RE: DEP File No. 0570008-044-AC; PSD-FL-336
CARGILL FERTILIZER, INC. - RIVERVIEW FACILITY, NO. 6 GRANULATION PLANT
RESPONSE TO REQUESTS FOR ADDITIONAL INFORMATION

Cargill Fertilizer, Inc. (Cargill) and Golder Associates Inc. (Golder) have received the Department's requests for additional information (RAIs) dated November 5, 2003, and November 14, 2003, concerning the permit no. 0570008-044-AC; PSD-FL-336 for modification of the No. 6 Granulation Plant (formerly EPP Plant). The comments are addressed below in the order they appear in each letter.

November 5, 2003 RAI

November 14, 2003 RAI

Attachment A, List of Attachments

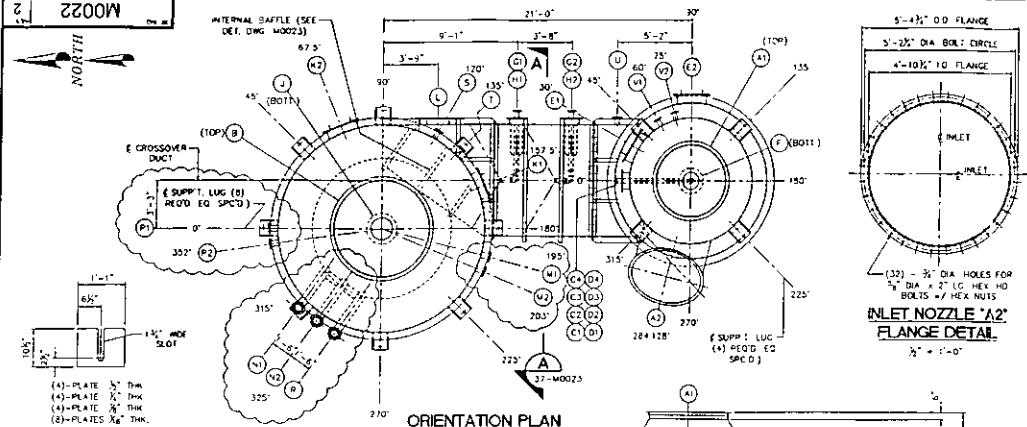
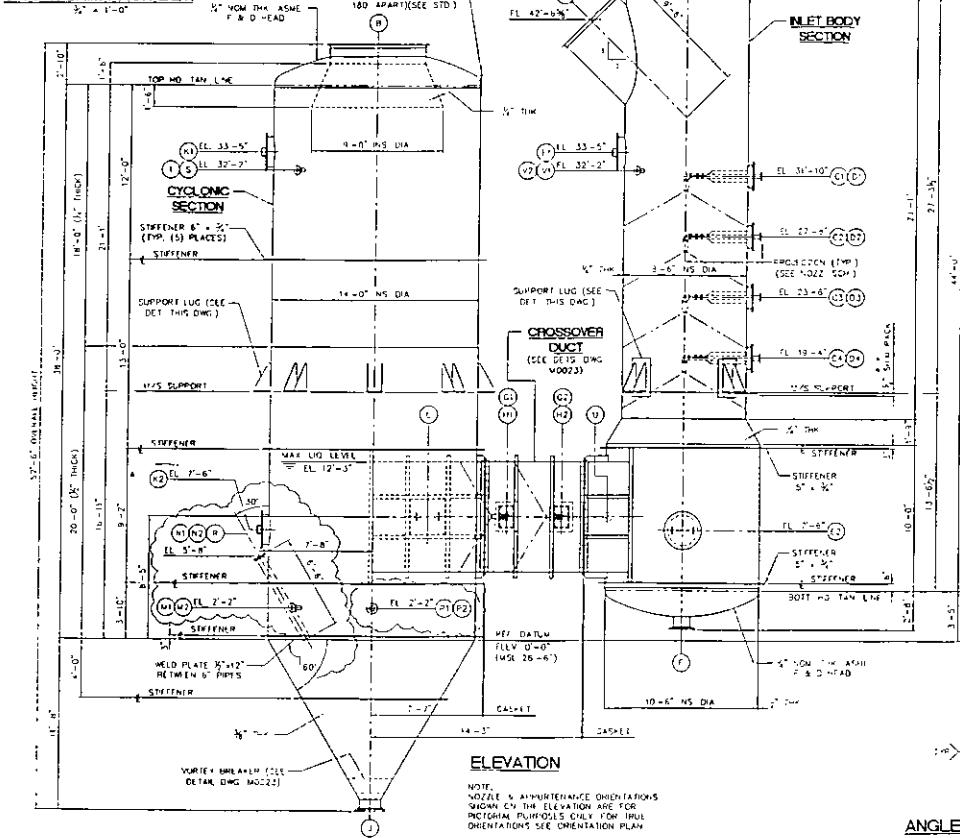
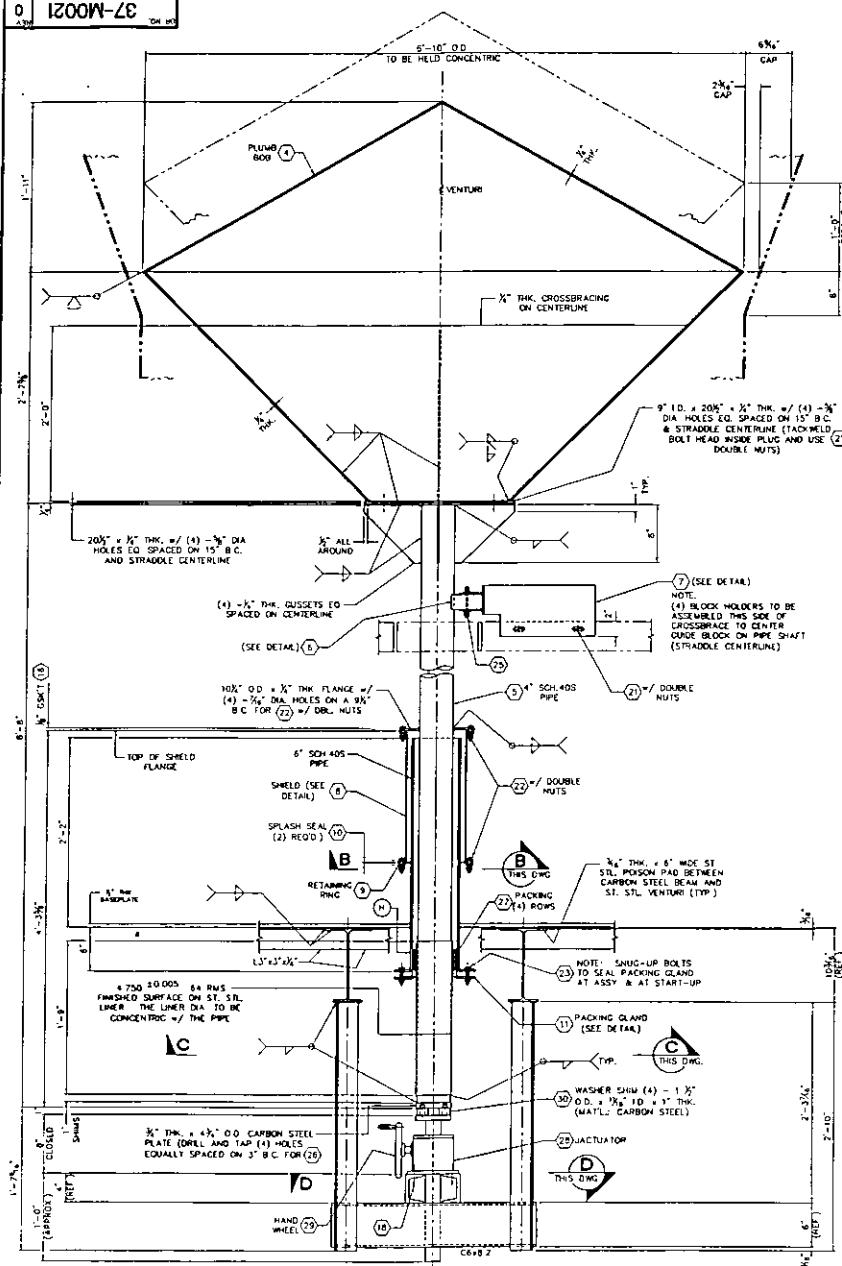
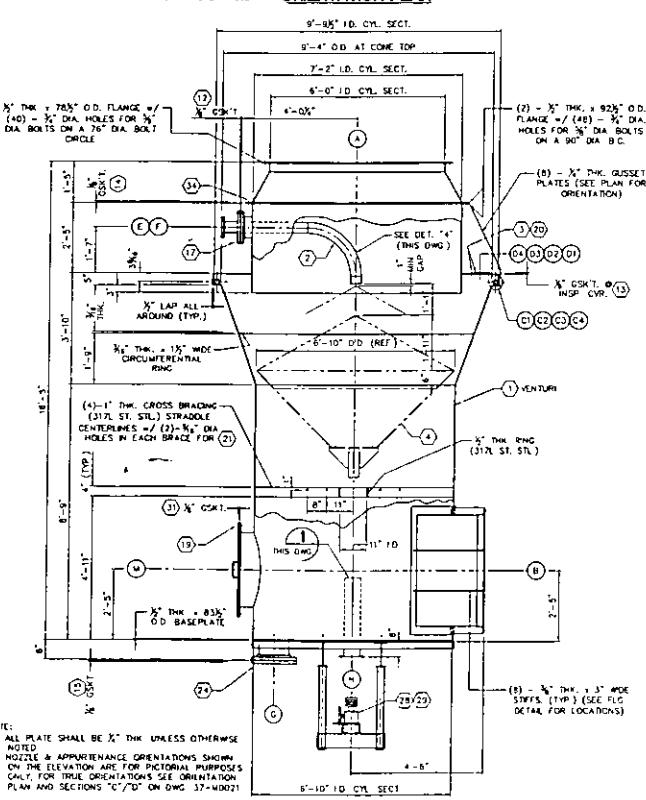
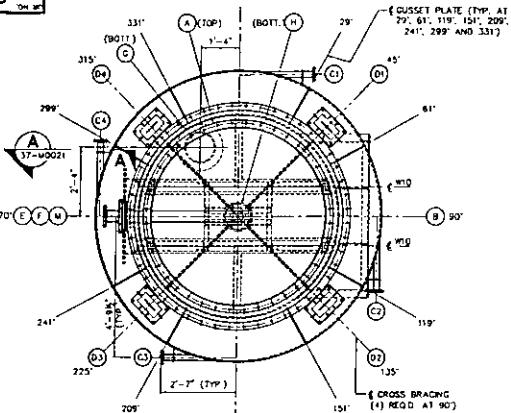
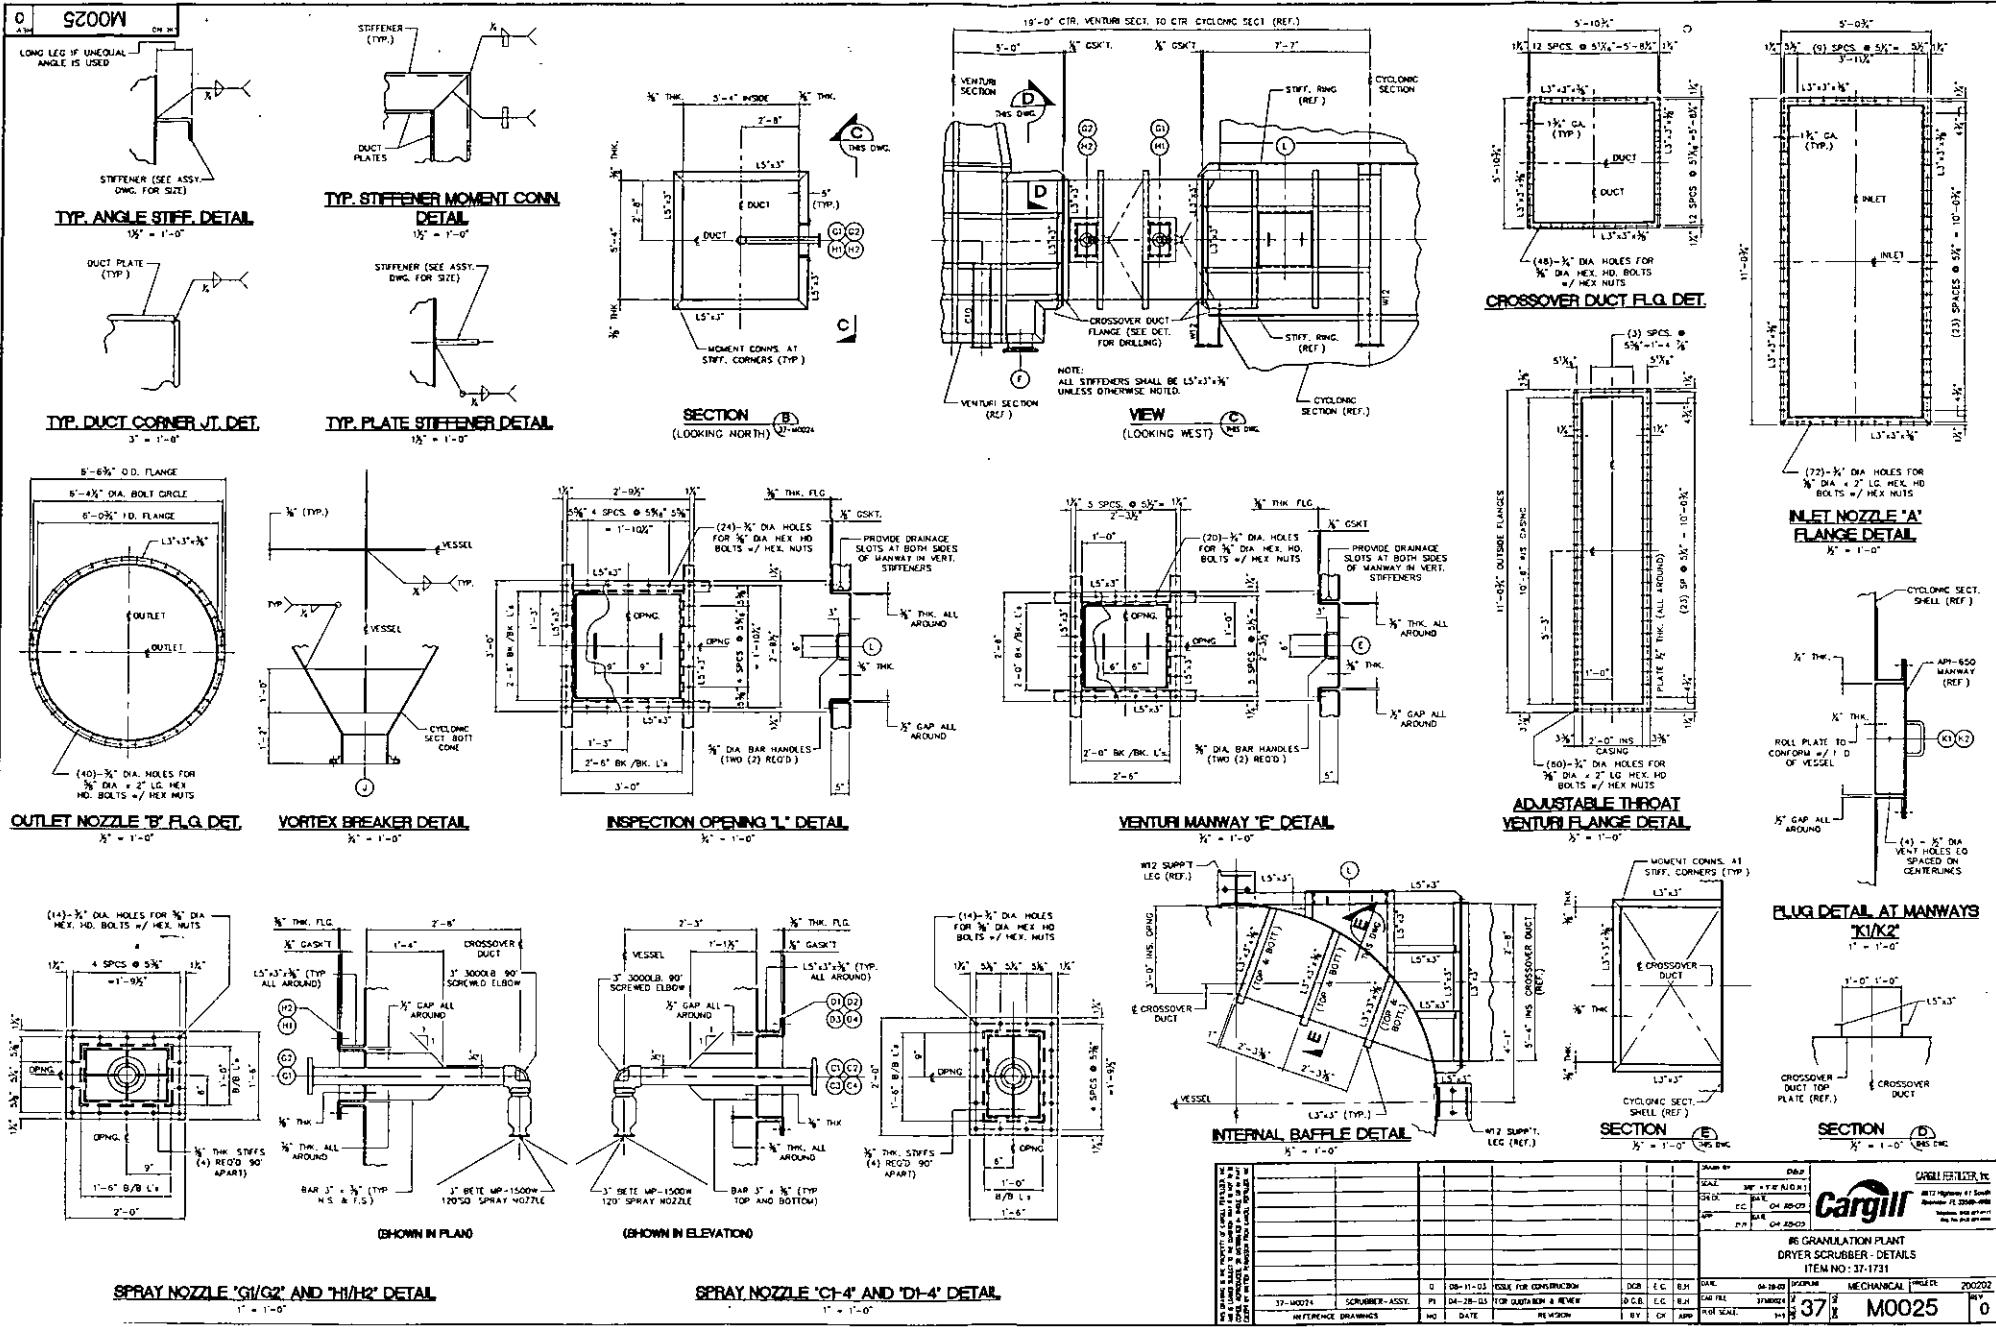
1. Please provide sufficiently detailed drawings of the scrubber systems being relocated and the proposed new scrubbers to allow a proper engineering evaluation of their expected performance. Also provide sufficiently detailed engineering descriptions of the new and existing scrubbers including calculations of their design efficiencies for PM/PM₁₀ and fluoride removal. [Rule 62-4.070(3), F.A.C., Standards for Issuance or Denial of Permits. Rule 62-212.400, F.A.C., Prevention of Significant Deterioration/Best Available Control Technology]

Detailed drawings of the scrubber systems are included in Attachment A. The design of the emission control systems proposed by Cargill for this project are based on actual performance tests from the similar system in operation at Cargill's Green Bay North MAP/DAP Plant, rather than on theoretical design efficiencies.

**DATA SHEET
PIPE REACTOR**

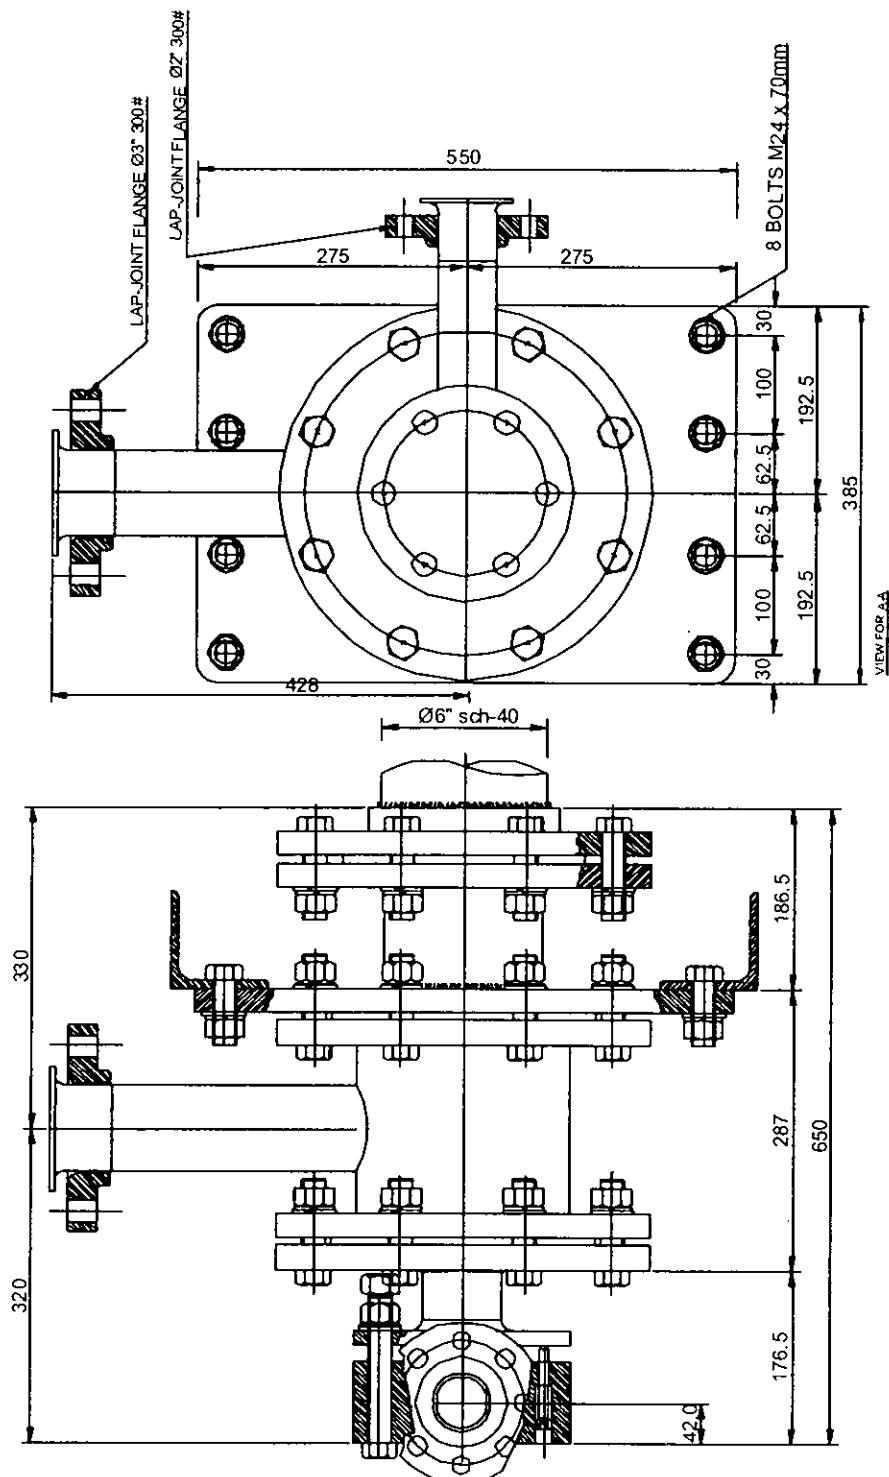
2. What is the capacity of the new Pipe Reactor and the new reactor that will replace Reactor Nos. 1 & 2? Submit design drawings and specifications of all the proposed new equipment.

The capacity of the new Pipe Reactor is 40 percent of the total capacity, or 1,791 TPD AP. The capacity of the new reactor that will replace Reactor Nos. 1 and 2 is 60 percent of the total capacity, or 2,687 TPD AP. The design drawings and specifications are included in Attachment B.
